August 4, 2011

RE: WAYNE COUNTY
WOOSTER TOWNSHIP
MILLER ALLOTMENT
CONSTRUCTION STORM WATER

Figure 3 – The diversion that leads to Retention Basin A lacks stabilization.

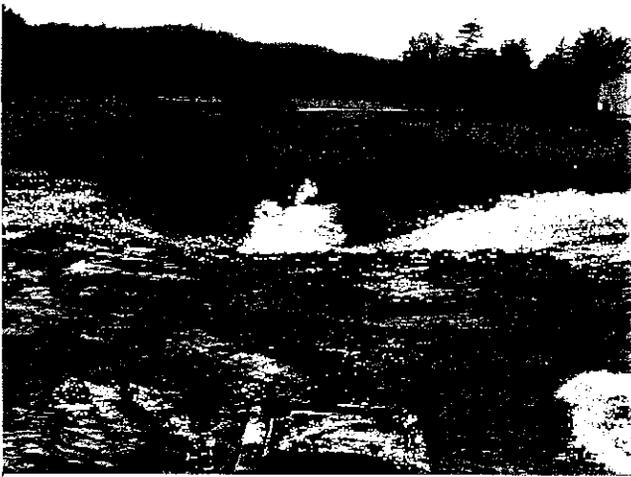
2. While much of the area has been seeded since my last inspection, some areas still lack stabilization. Please monitor the entire site to ensure that vegetation takes root and begins to fill in appropriately. In addition, please repair and reseed all erosion gullies that have formed along the road (Figure 2). Finally, please stabilize the diversion that carries water to Retention Basin A to prevent erosion and reduce the amount of sediment that collects in the basin (Figure 3).
